Hume Planning Scheme Amendment C207 and C208

Expert Witness report provided to Planning Panels Victoria

Drainage Evidence

(C208 - Property 1,2 and C207 - Property 61,64,687)

**Figure 28:** Plan view of designed wetland structure

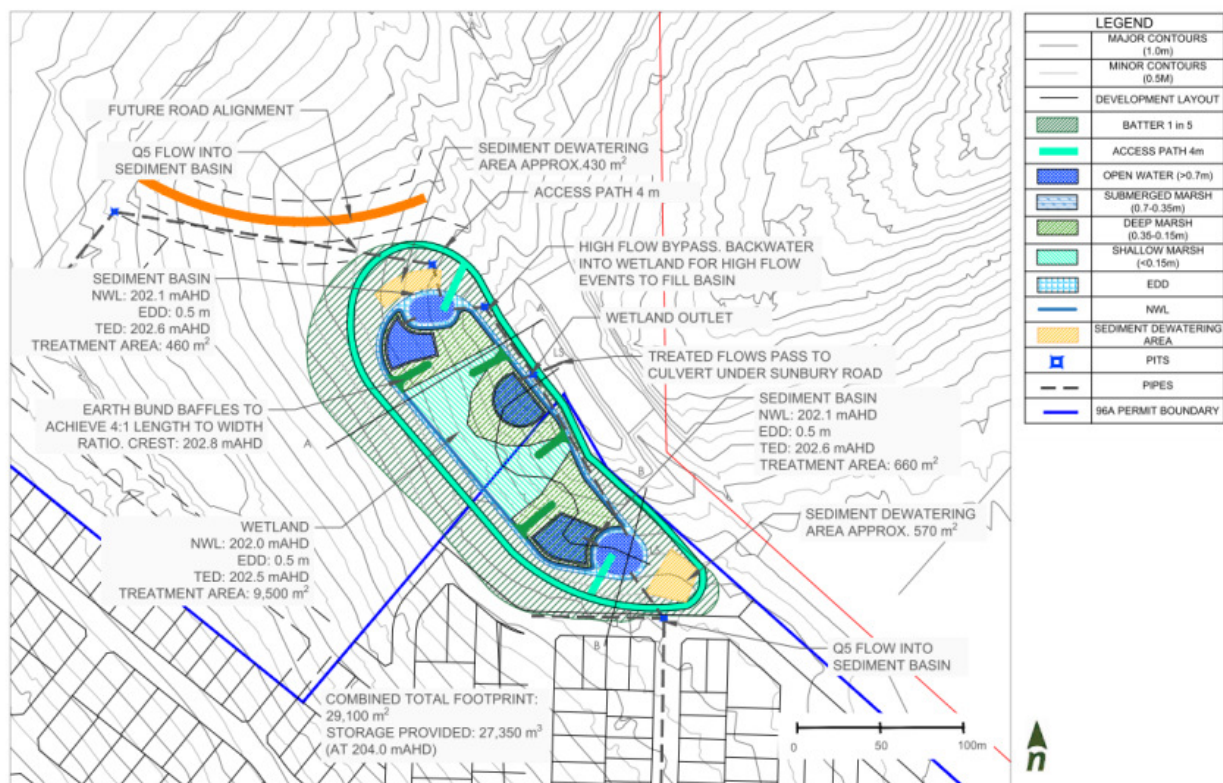
As described above and shown in Figure 28, the total revised treatment asset footprint can be accommodated with Villawood's 96A permit boundary. The revised asset meets Melbourne Water's original objectives for Shepherds Lane DSS in providing water quality and quantity treatment. Therefore in my opinion the original objection raised by Melbourne Water's has now been satisfied.

**Figure 34:** Wetland asset WI-21 – Alternative configuration versus June DSS reserve

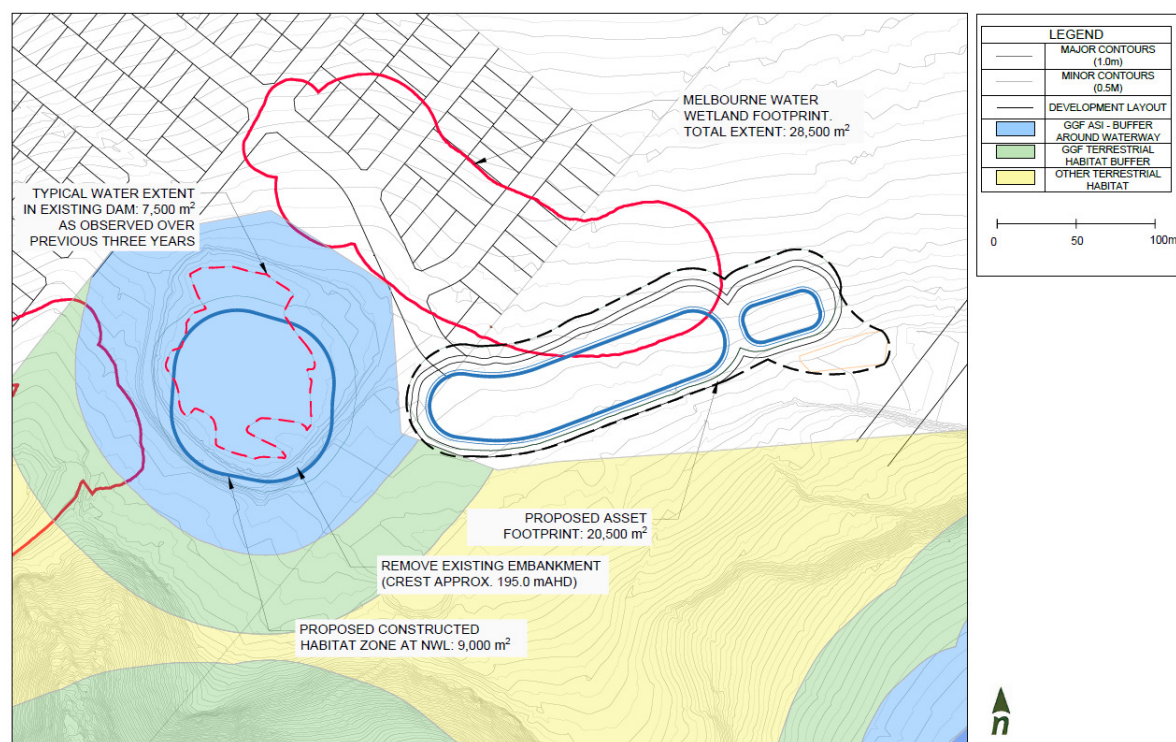
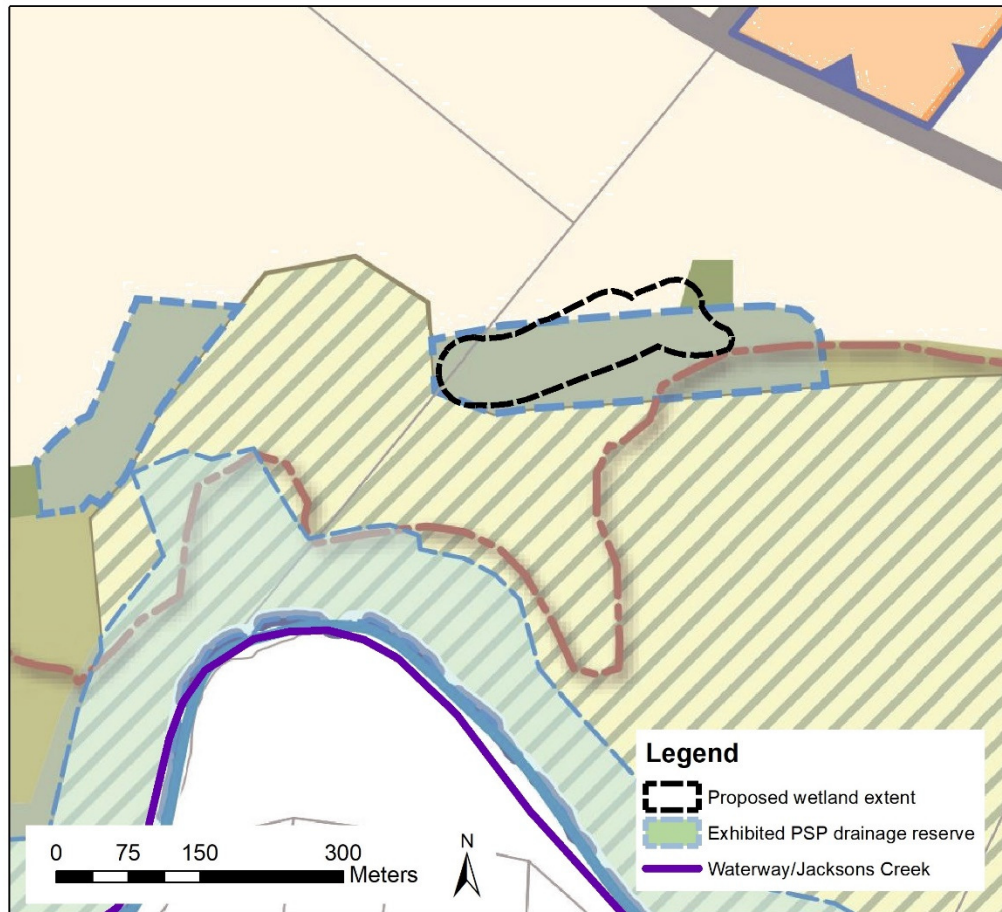
A comparison of the proposed alternative configuration of asset WI-21 and Melbourne Water's June revision to the DSS are shown in Figure 34. A comparison of the proposed alternative configuration of asset WI-21 with the exhibited PSP is shown in Figure 35.

**Figure 40:** Functional layout of alternative configuration for WI-19

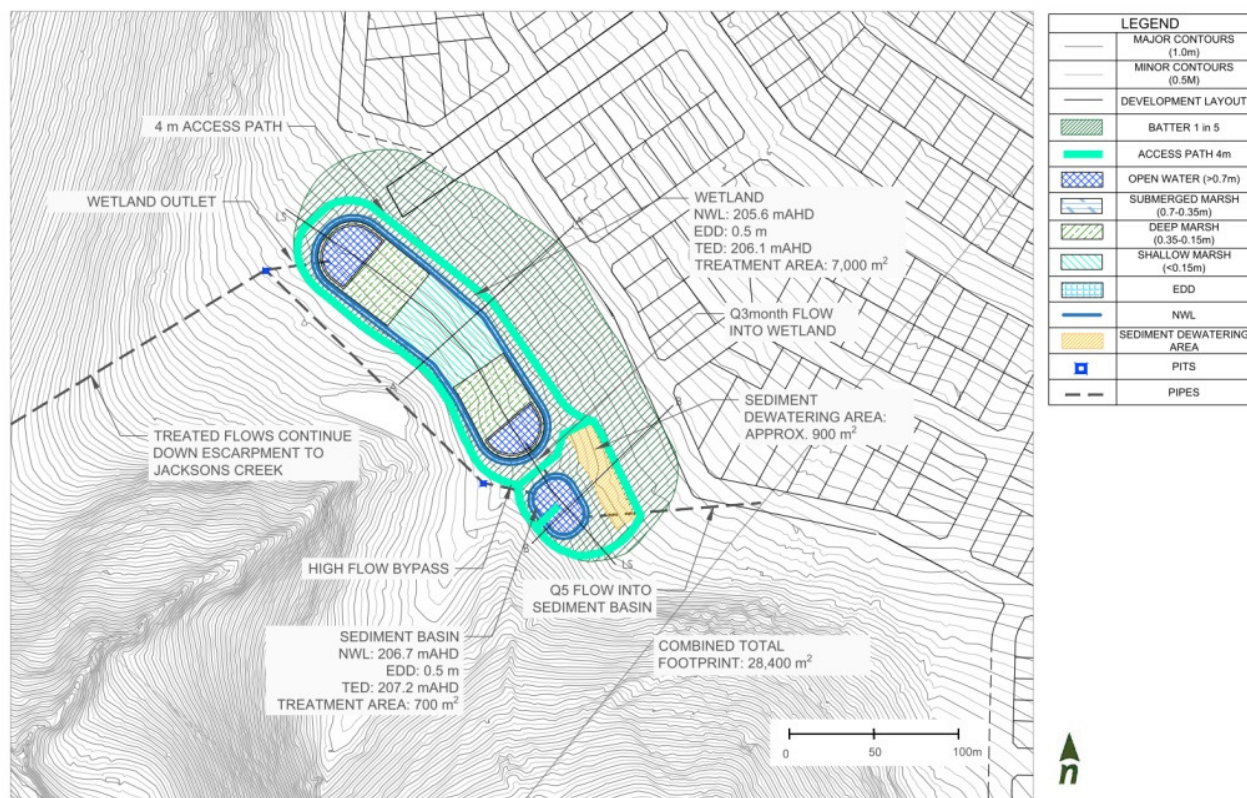
Figure 40 shows the functional layout of the alternative designs for WI-19. The distance from the top of the escarpment to the limit of excavation is generally in excess of 40 metres, with only an isolated pinch point of about 15 metres near the sediment pond.
